CITY OF CODY
PLANNING, ZONING AND ADJUSTMENT BOARD AGENDA
TUESDAY, April 25, 2023
CITY HALL COUNCIL CHAMBERS @ 12:00 NOON

**CITY OF CODY
PLANNING, ZONING AND ADJUSTMENT BOARD
STAFF REPORT**

MEETING DATE:	APRIL 25, 2023	TYPE OF ACTION NEEDED	
AGENDA ITEM:		P&Z BOARD APPROVAL:	X
SUBJECT:	SITE PLAN REVIEW, AND SPECIAL EXEMPTION PUBLIC HEARING AND REVIEW: MOORE STORAGE (MINI-STORAGE) FACILITY. SPR2023-07 AND SUP2023-05	RECOMMENDATION TO COUNCIL:	
PREPARED BY:	TODD STOWELL, CITY PLANNER	DISCUSSION ONLY:

MEETING DATE:	APRIL 25, 2023	TYPE OF ACTION NEEDED	
AGENDA ITEM:		P&Z BOARD APPROVAL:	X
SUBJECT:	SITE PLAN REVIEW: PILOT PEAK DOG WASH FACILITY. SPR 2023-08	RECOMMENDATION TO COUNCIL:	
PREPARED BY:	TODD STOWELL, CITY PLANNER	DISCUSSION ONLY:

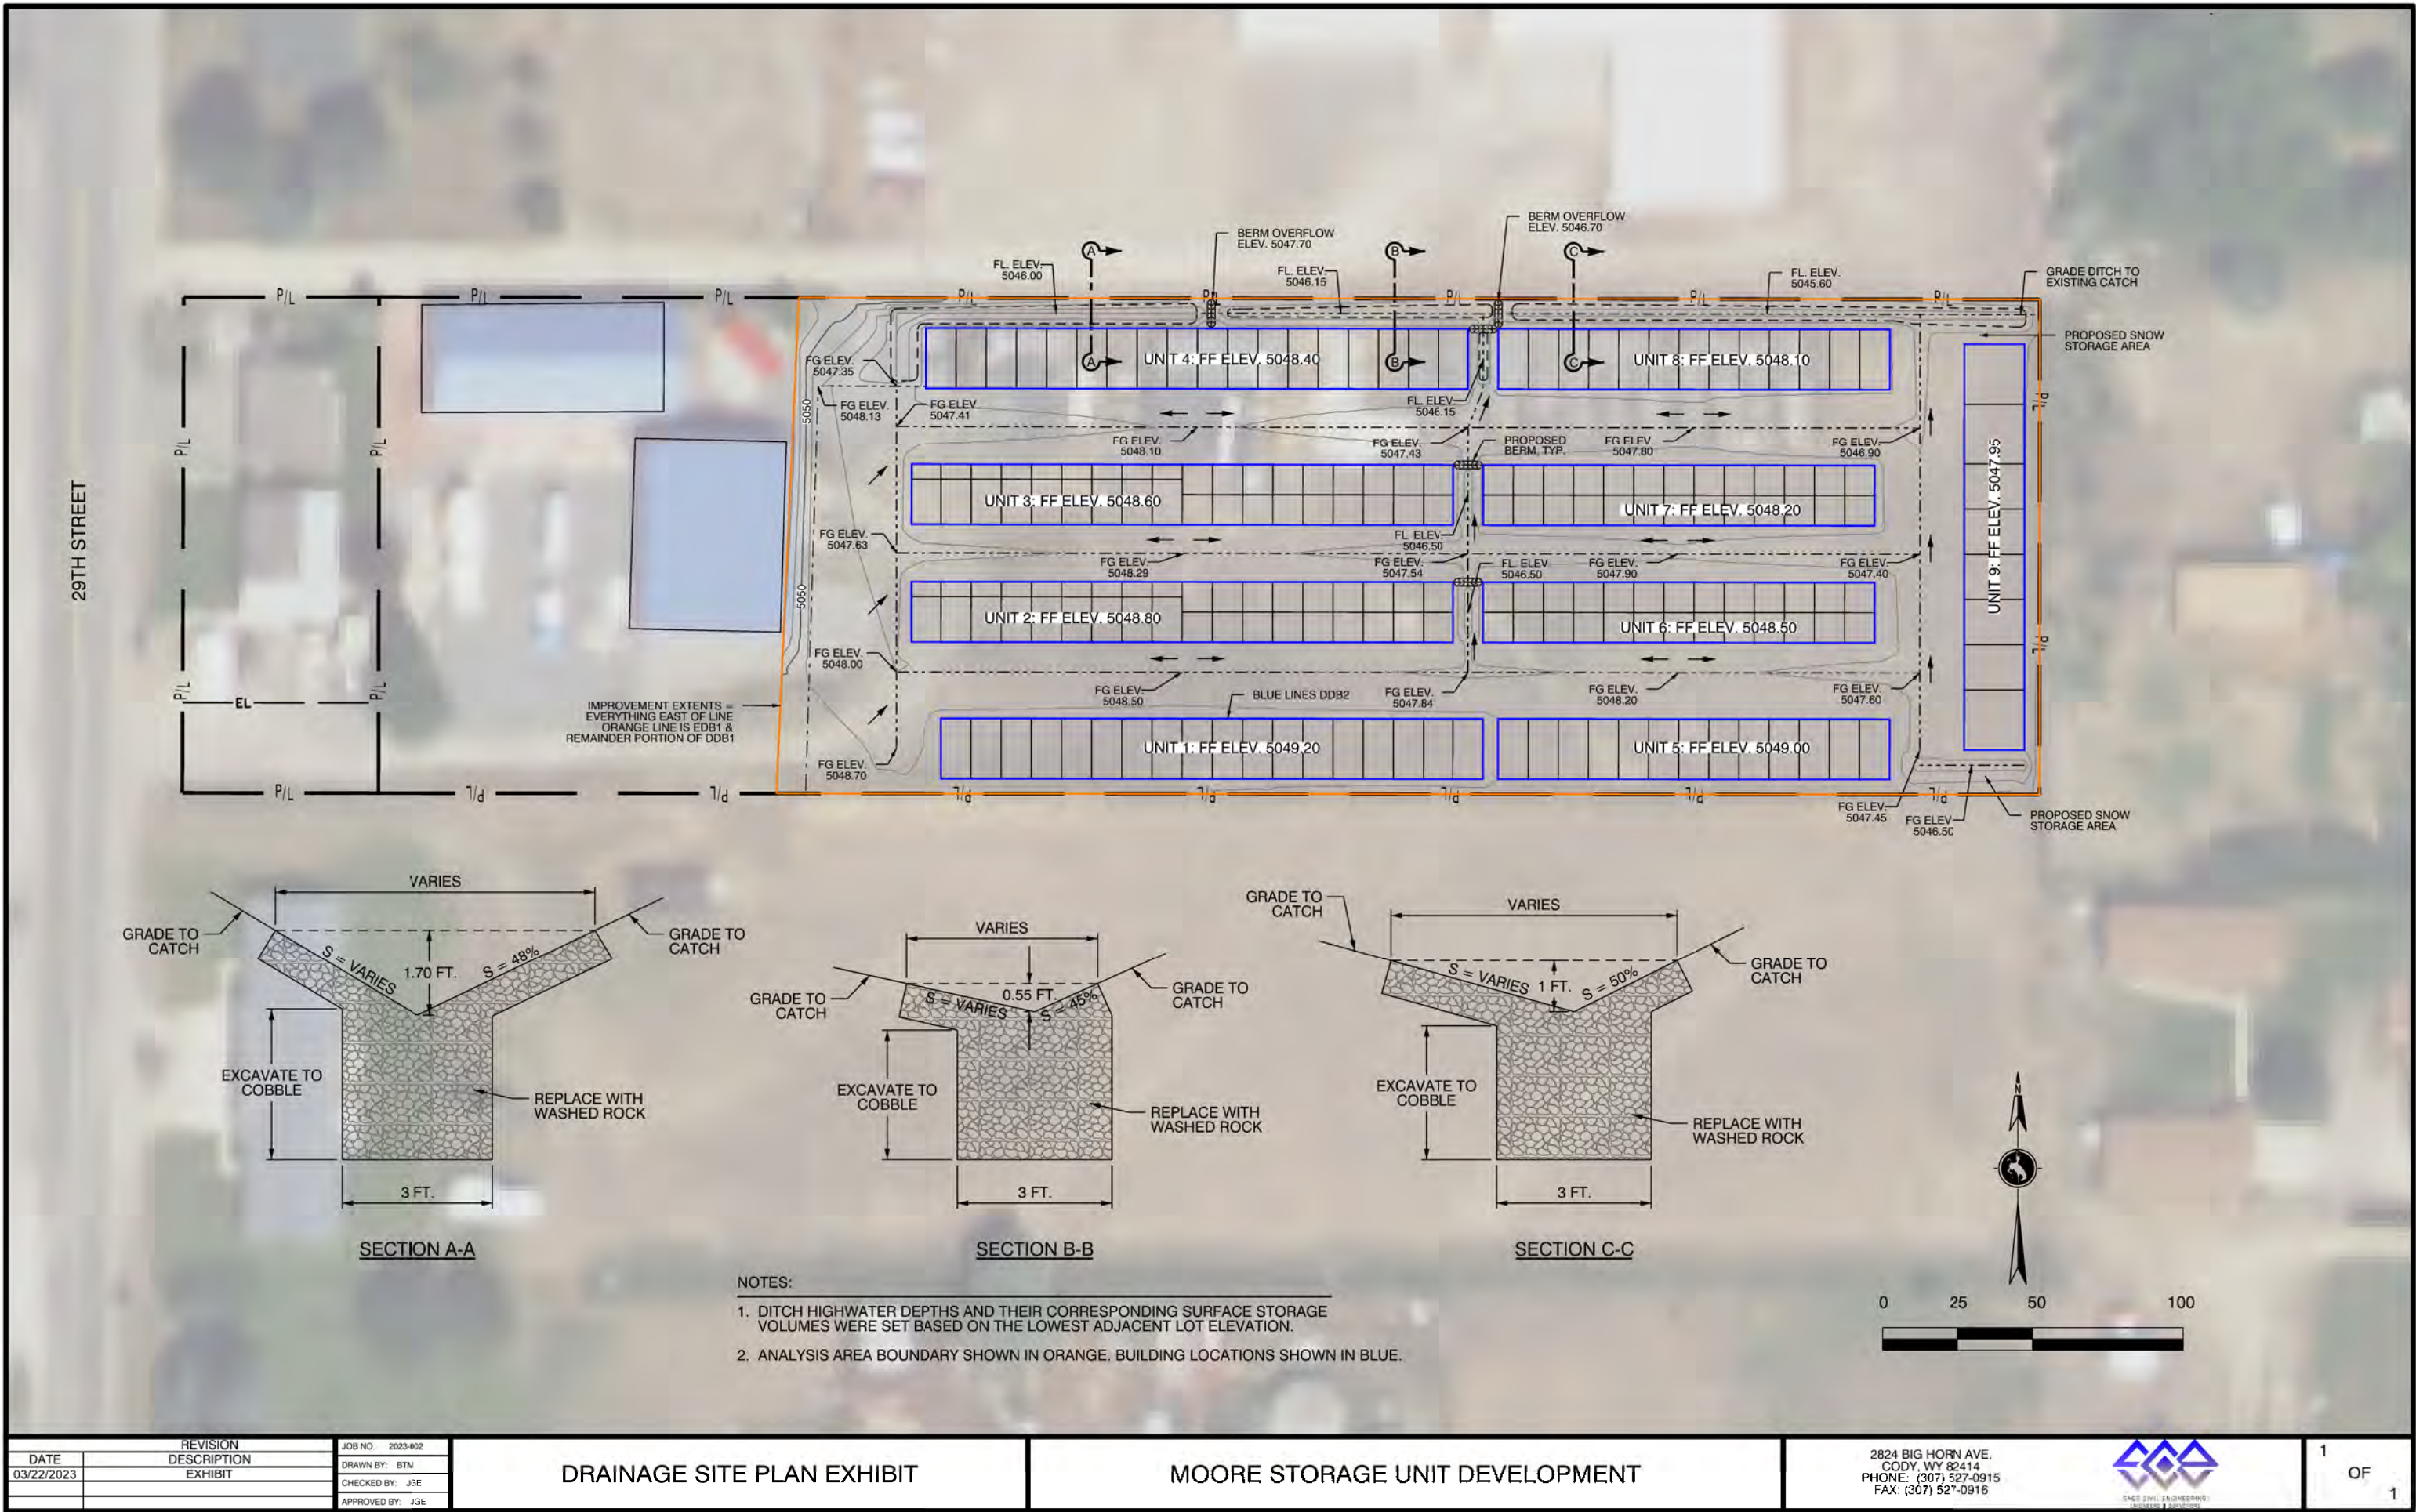
Post development will continue a north/northeasterly flow pattern. All run-off will collect in one of the four proposed percolation/storage trenches located north of and in between Units 1 and 2. All drainage swales will be constructed as a V-Ditch configuration. Sediment traps are proposed in between the units to settle out collected fines within the runoff and eventually discharge clean water over the berm. While these areas will disperse runoff through storage collection and percolation, no credit was taken between Units 2 and 6 and 3 and 7. The surfacing plan includes using washed rock over compacted crushed base. If maintained, the water will flow slowly through this rock on top of the crushed base preventing washing of fines.

Per the Storm Water Management Plan (SWMP), section 3.6.4, the percolation trench design is to be based on a 25-year, 2-hour event for the percolation trenches, therefore I = 0.66 in/hr. The storm volume calculations are shown below.

In total, the percolation trench will store/perc 3,690 ft³ of water, which is in excess of the required 3,143 ft³. The design storm is satisfied while ignoring a significant portion of excess capacity due to over excavation and replacement of washed rock. Therefore, the drainage facilities have more than enough capacity to fulfill requirements above and beyond the design storm.

- 6) Once constructed, the applicant's engineer must provide a certification that the storm water facilities have been constructed as approved prior to occupancy of the buildings.

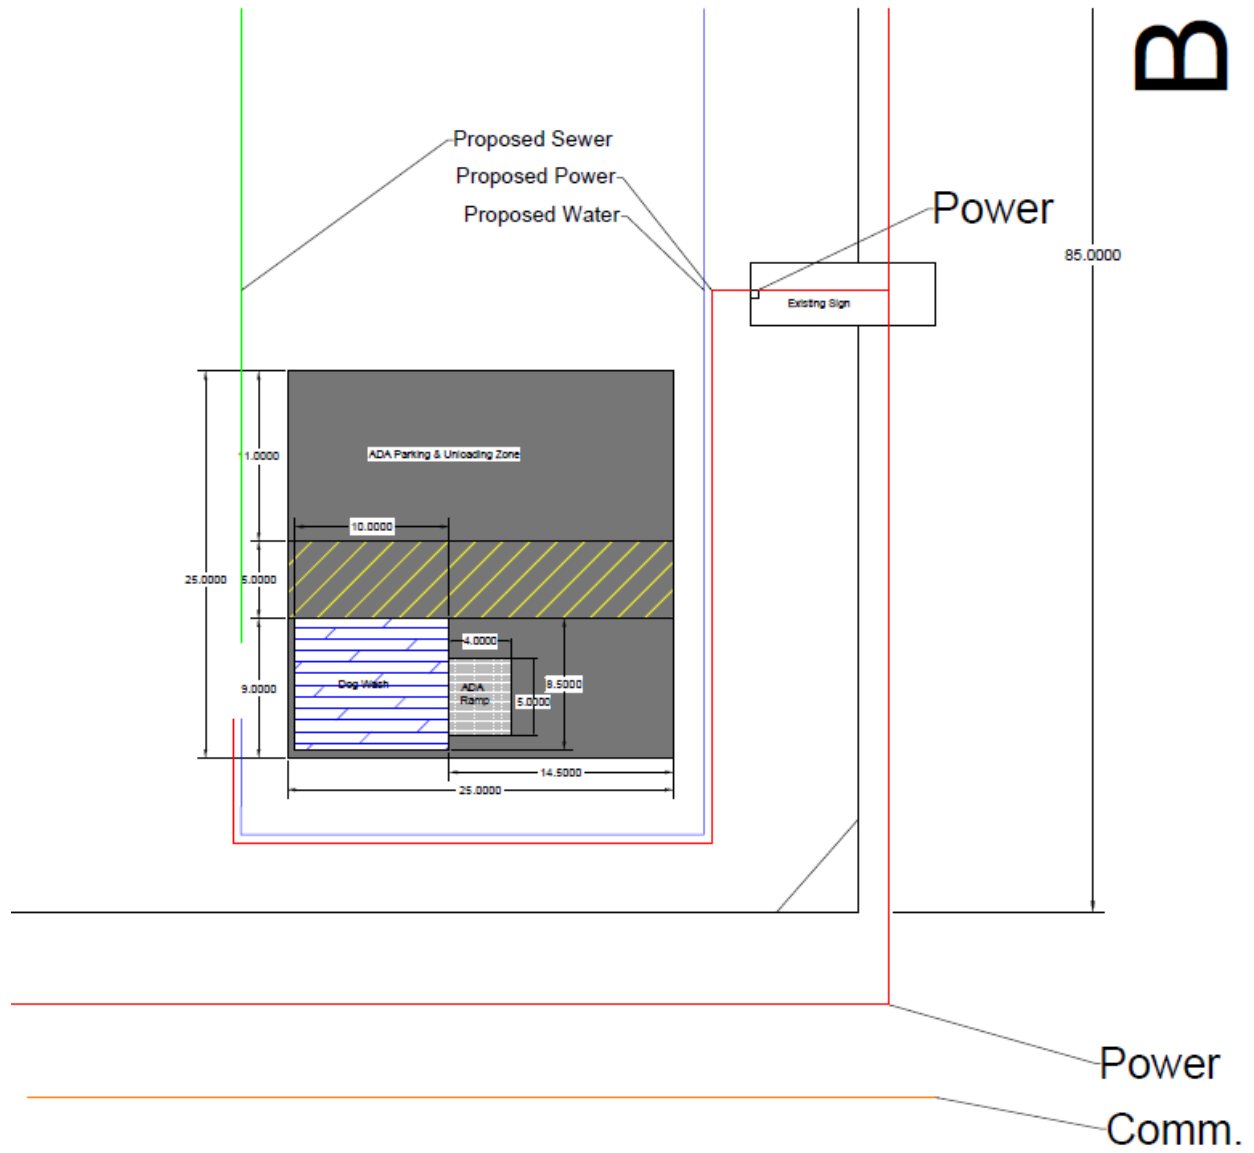
The site plan places the structure on the southwest corner of a proposed 25' by 25' asphalt pad. Other portions of the pad are designated for a single ADA parking space and a ramp up to the building entry. The site plan does not show a standard parking space or the driveway location that would extend from the access point at the northeast corner of the property.

The City parking standards require the access road and standard parking space to be improved to a crushed gravel surface or better. Due to the existing cobble and pebble ground surface, it will not take much thickness of gravel, but it is necessary that some be added to provide the surfacing and to delineate the spaces and access drive. The driveway off of the entrance need only be 20 feet wide to meet fire code standards. Due to the minimal traffic, staff does not see a need to require a 24-foot-wide driveway all the way to the dog wash.

It is noted that if the asphalt pad were extended by two feet to the north, it could be striped in a manner to provide both the ADA space and a second, standard 9-foot-wide space. Both would face south, towards the dog wash building, with the ADA space on the east side.

3. Provide a standard parking space that meets the city parking regulations. It is recommended that it be accomplished by extending the asphalt two feet to the north and restriping as outlined in the staff report.

4. Provide a minimum 20-foot-wide access from the approach to the parking area, surfaced with crushed gravel or better.
5. If the coffee hut is also installed, the approach must be paved, as outlined in the staff report.
